Service Technical Information

MODEL NO. CSD-MD50
SUBJECT Clock becomes loses only in ECO mode

REF.No. :G - 99 - 054 - E0

DATE :08. NOV. 1999

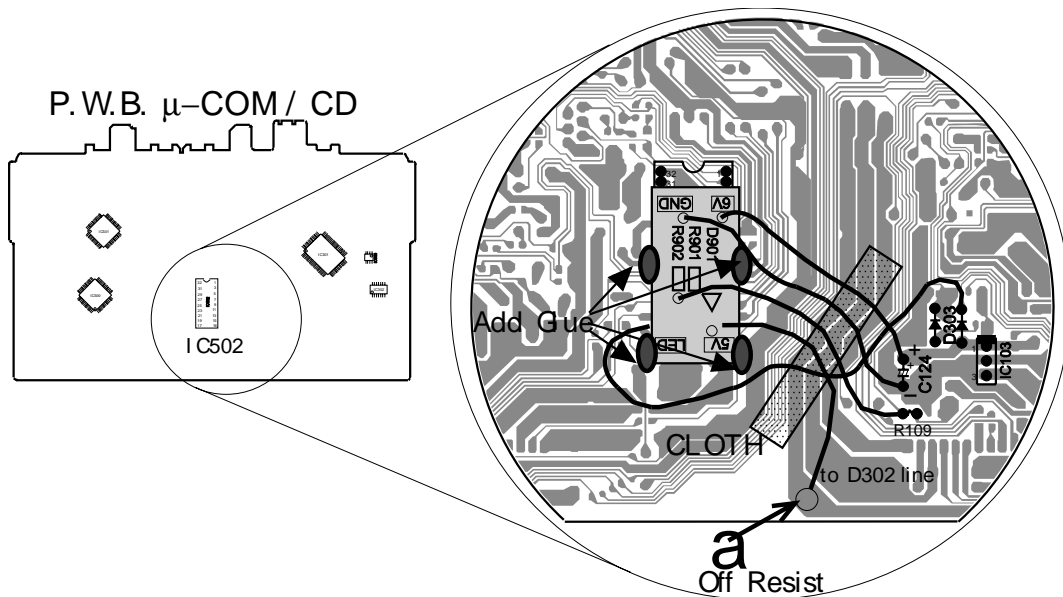
Clock becomes loses in the model concerned. Take the following remedies on the model in question, regardless of presence or absence of the symptom.

In ECO mode, the system clock becomes loses by one minute per day under standby status.

Take the following steps as shown in the figure below:

- 1) Remove the resist (a) off the P.W.B μ -COM/CD using a knife, etc.
- 2) Solder five wires of a repair P.W.B. SUB μ -COM.
- 3) Cut a cushion in half, and stick a piece of it on the P.W.B. SUB μ -COM.
- 4) Stick the P.W.B. SUB μ -COM with cushion onto the P.W.B μ -COM/CD. (on IC502 section).
- 5) Gather the wires and fix them down with CLOTH.
- 6) Lock down the P.W.B SUB μ -COM with glue (1600B) at four points.
